RESIDENTIAL PROJECT REVIEW COMMITTEE (RPRC) APPLICATION

RESIDENTIAL PROJECT REVIEW COMMITTEE ENGINEERING REVIEW	
Date	August 14, 2020
Project Name	Joseph Daniel
Street Location	45 Byram Ridge Road
Section, Block & Lot	101.03/3/24
<u>Engineering Comments:</u>	
<p>1. The location of the property line should be clarified. There appears to be two similar lines offset with dimension pulled to each.</p> <p>2. The site plan shall illustrate the entire property limits.</p> <p>3. Provide an Existing Conditions Plan illustrating all features and those to be removed, including but not limited to, the residence, drive, walks, well, septic, overhead utilities, etc.</p> <p>4. Illustrate existing topography.</p> <p>5. The improvements within the Town right-of-way will require a Street Opening Permit from the Highway Department. All proposed improvements shall be detailed, per the Town Highway Department standards.</p> <p>6. The plan shall demonstrate that the minimum required Westchester County Department of Health (WCHD) setbacks to the infiltration system/domestic well/proposed improvements are met. The proposed storm connection for the slot drain is not shown on the plan. Assuming it will dis

Left Side Elevation
Scale: 1/4" = 1'-0"

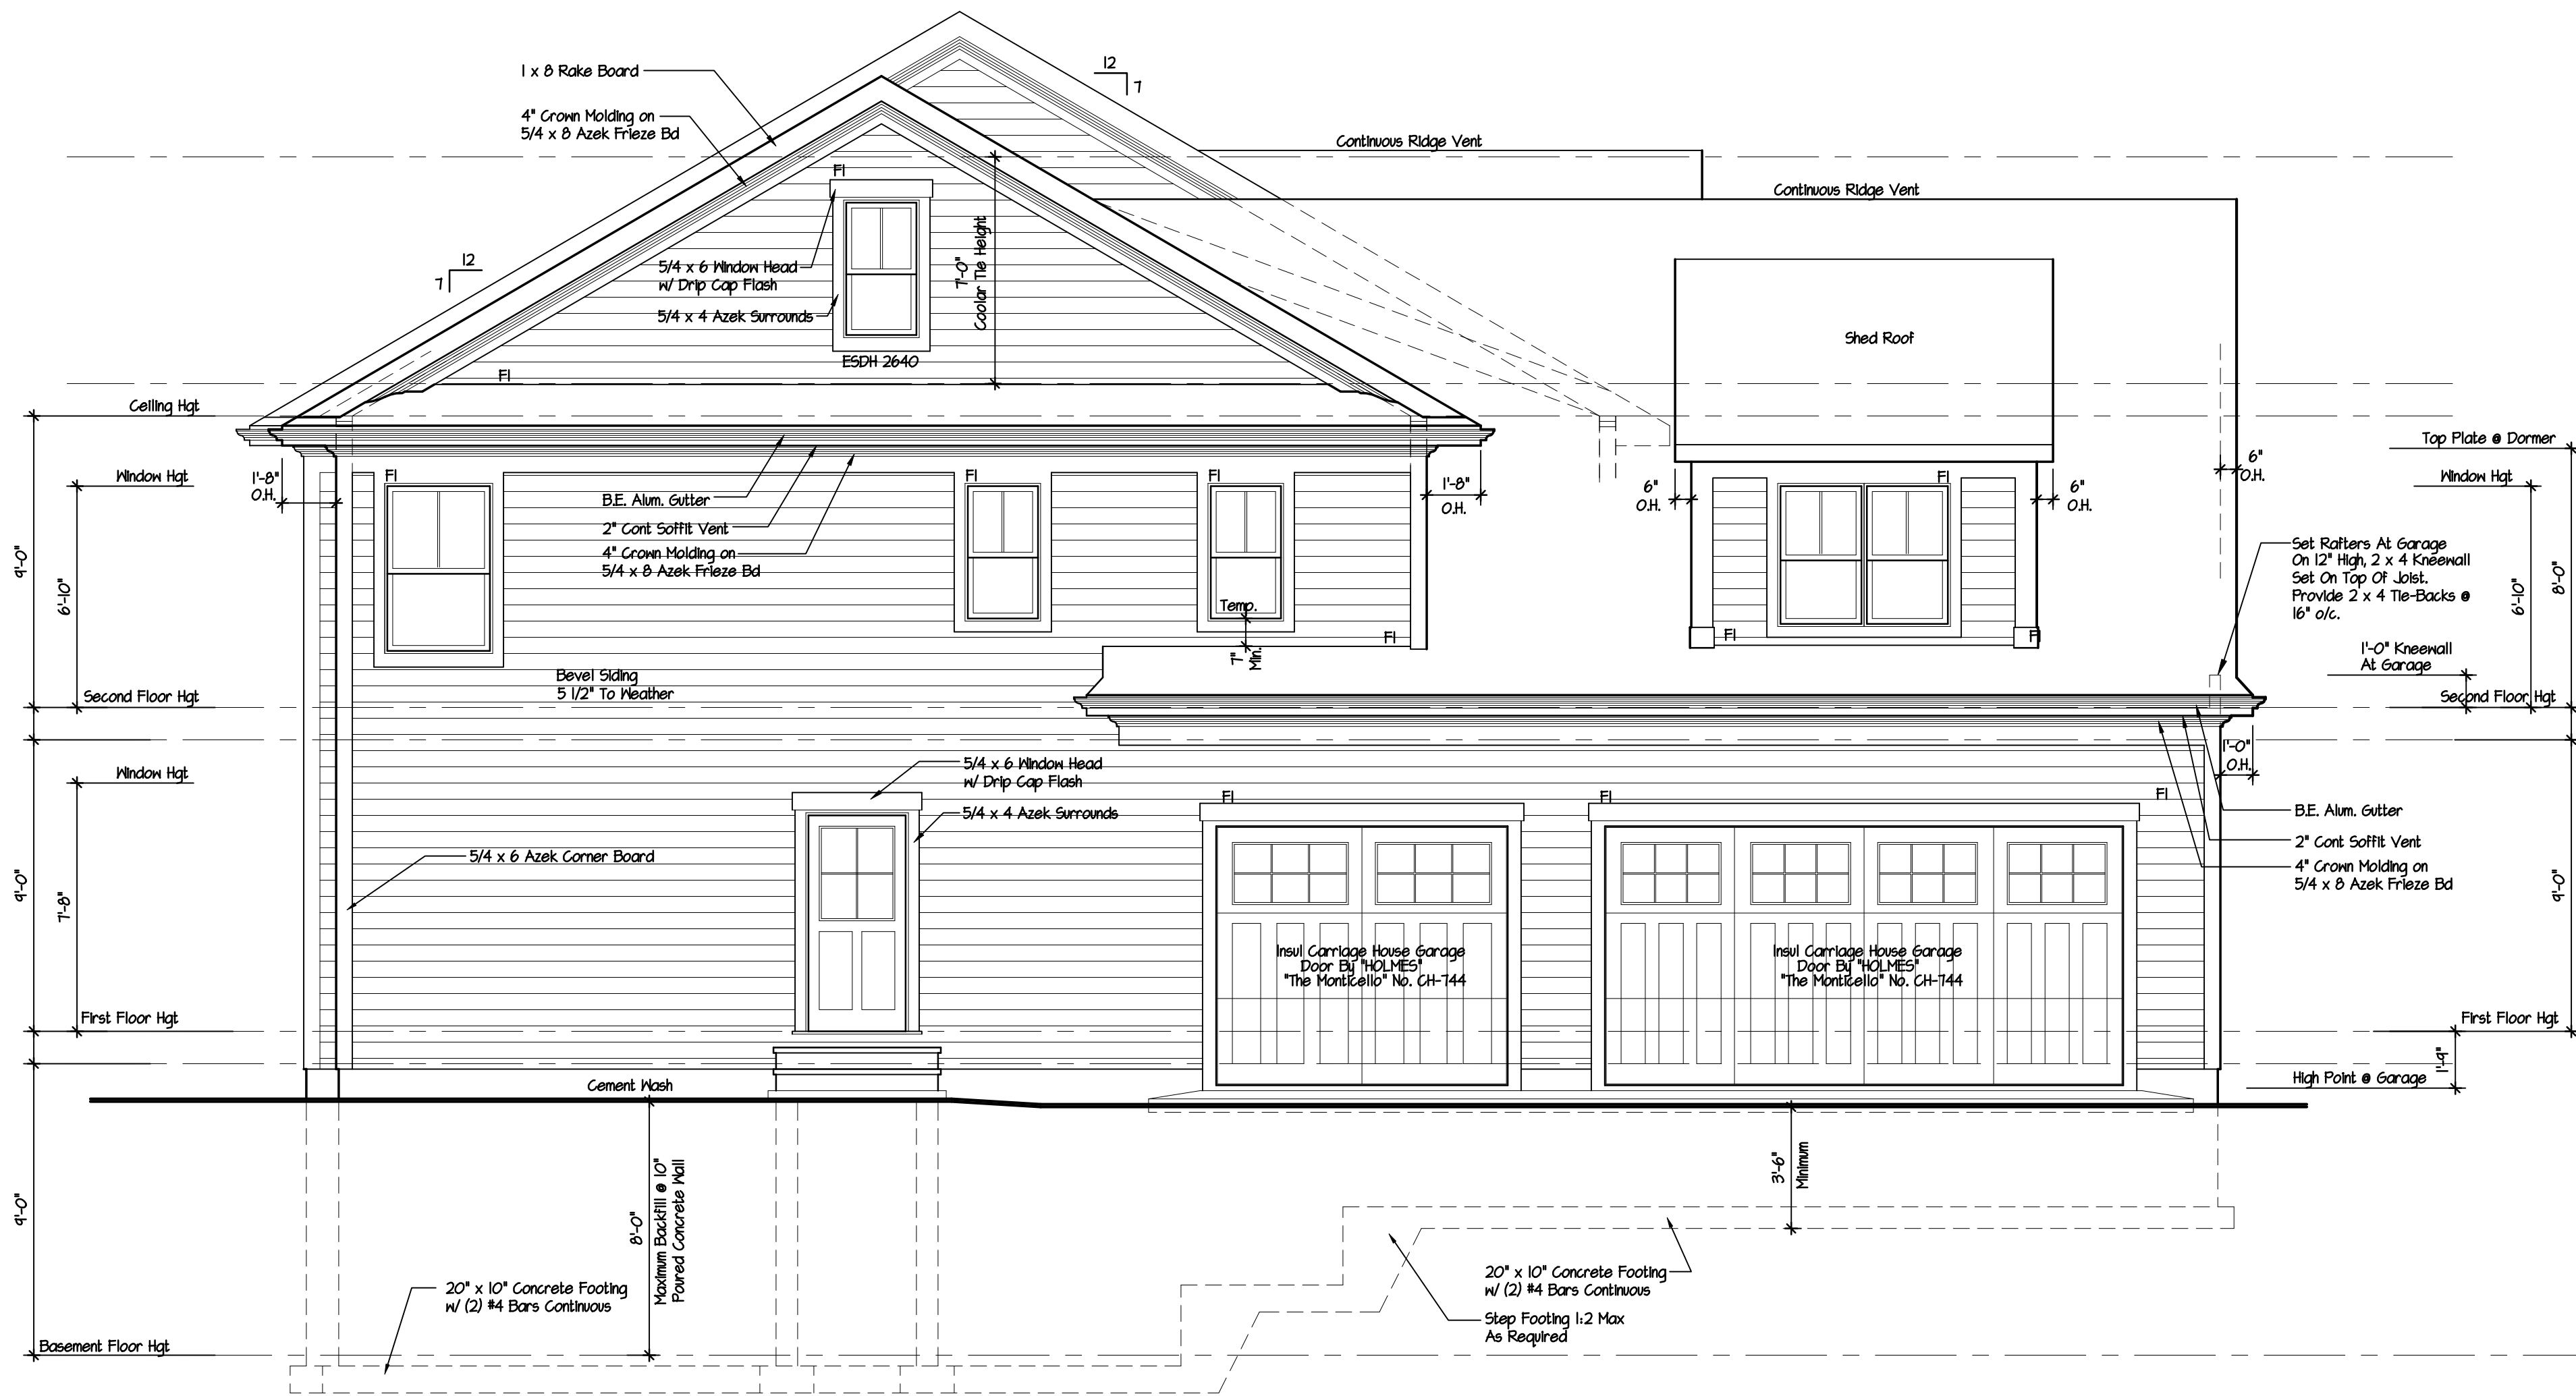
The maximum exterior wall height calculation on the left side is not correct. Max Exterior Wall Height should be measured from the bottom of the proposed well to the midpoint of the roof.

- Architect revised

Landscape Plan
 45 Byram Ridge Road
 Armonk, NY

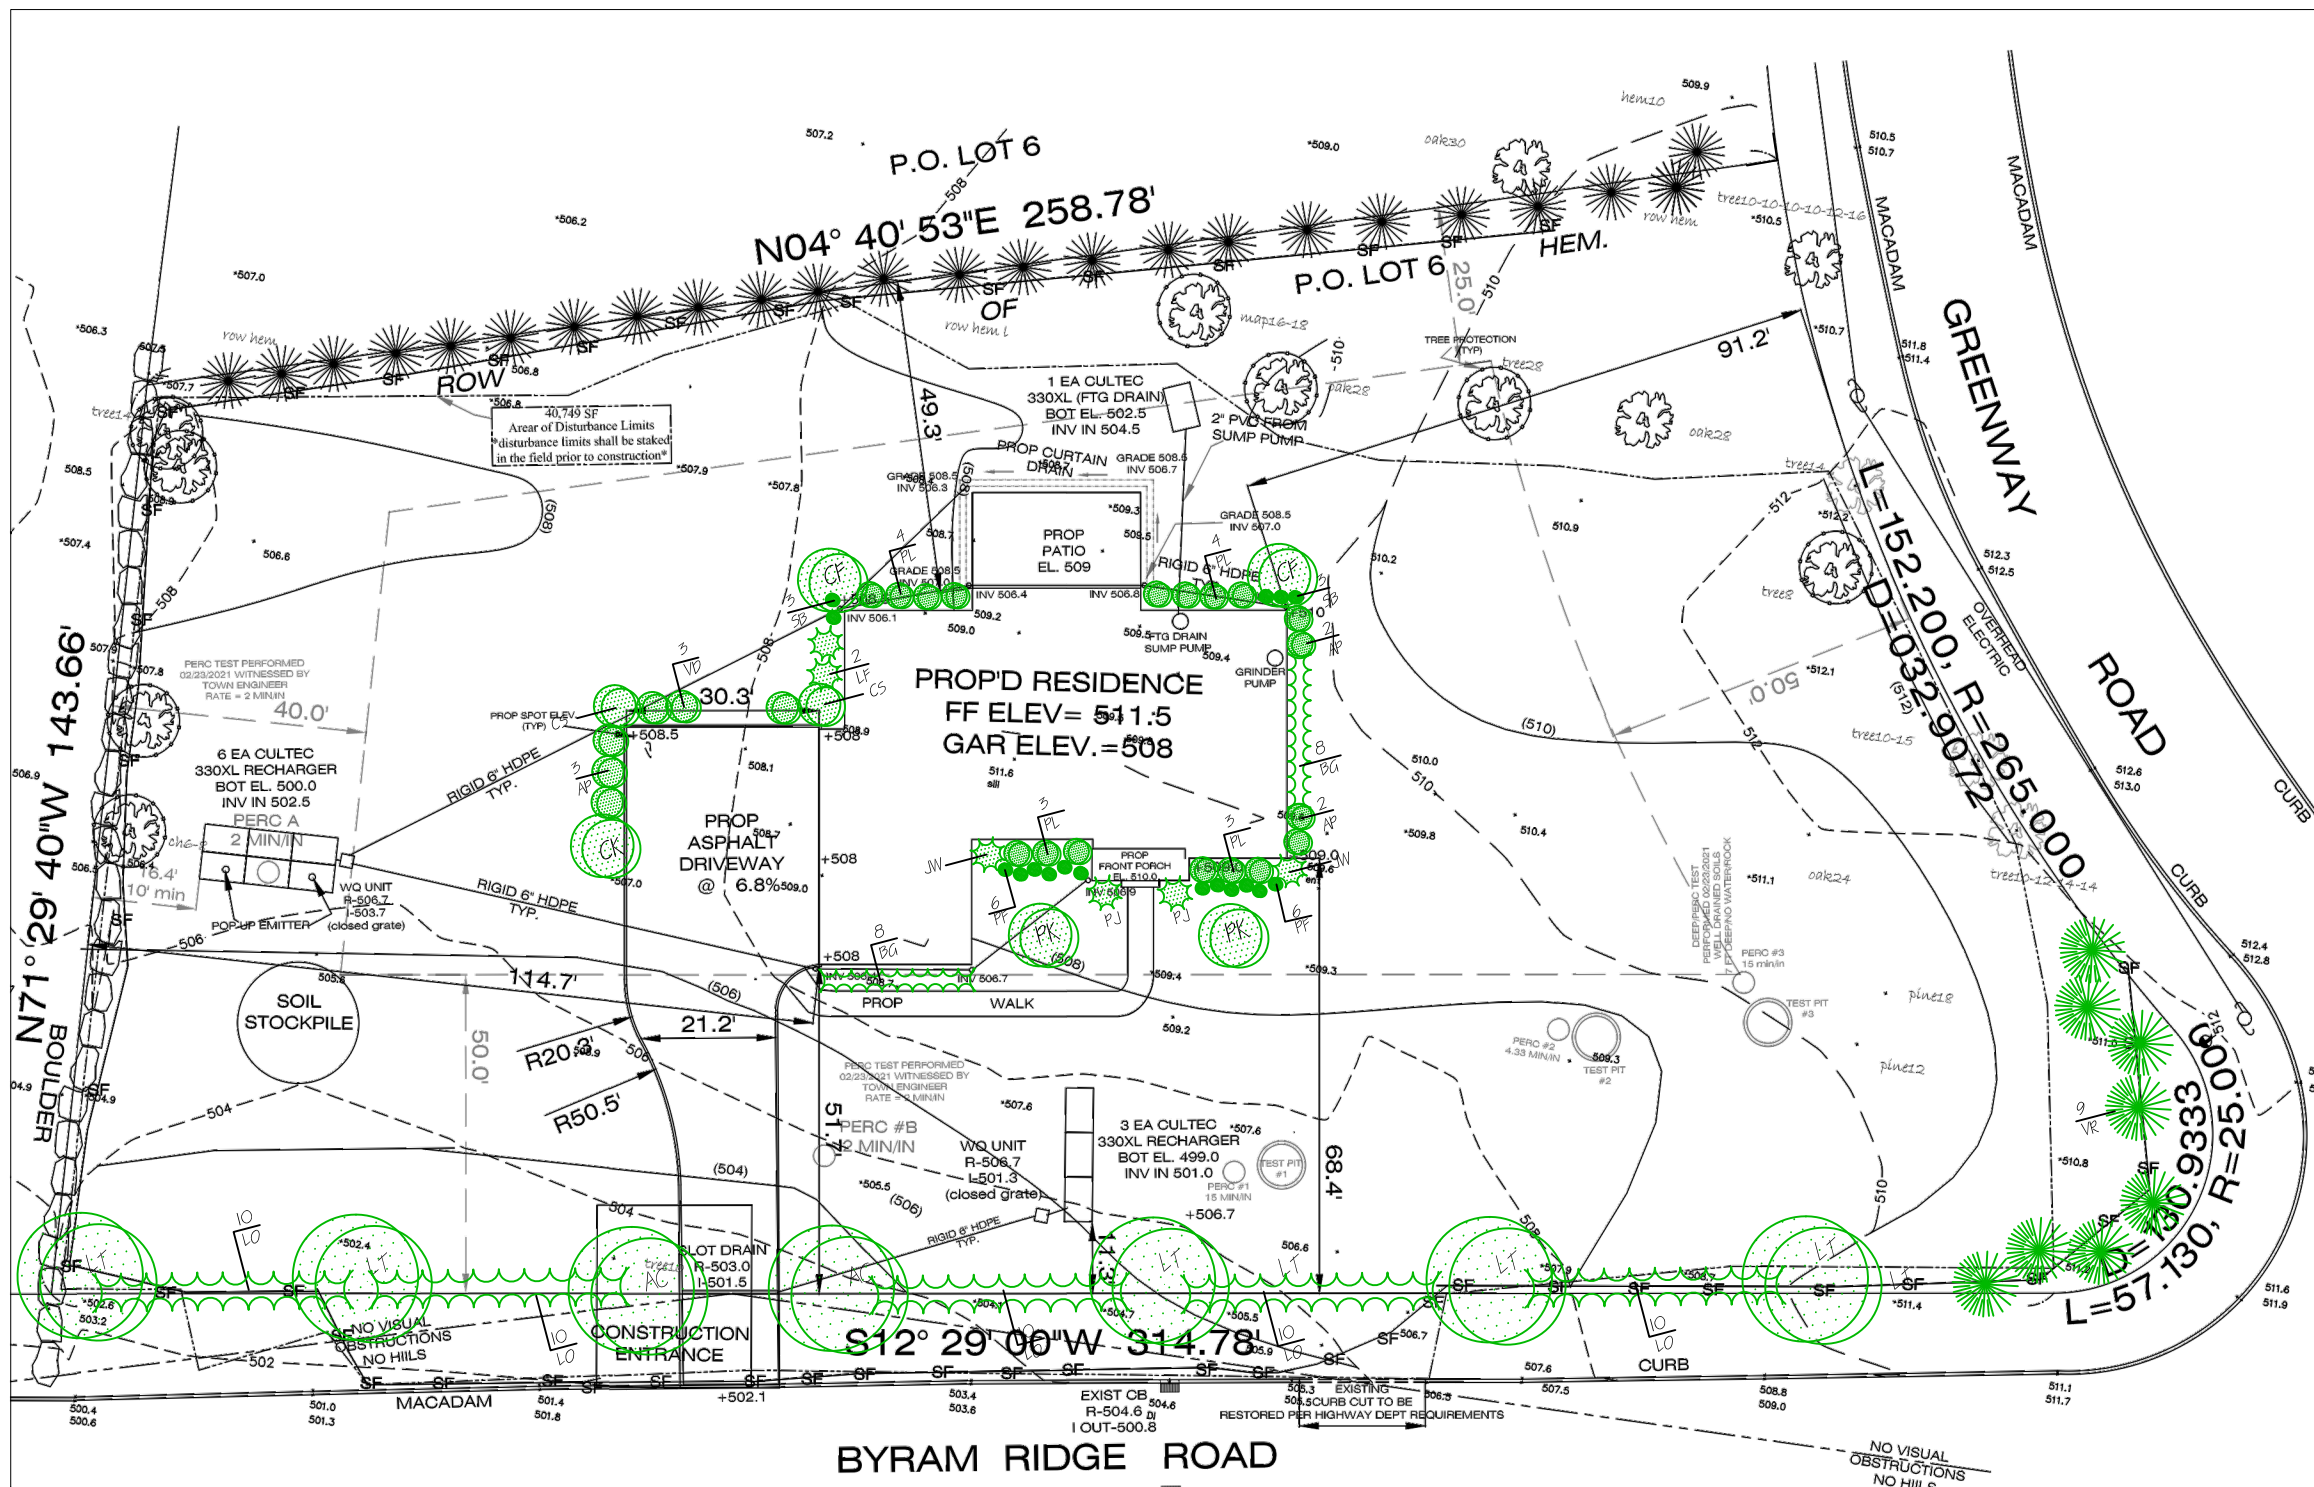
8 trees are proposed to be removed. It is recommended that the Applicant provide a landscaping plan for review.

- Landscape plan provided.
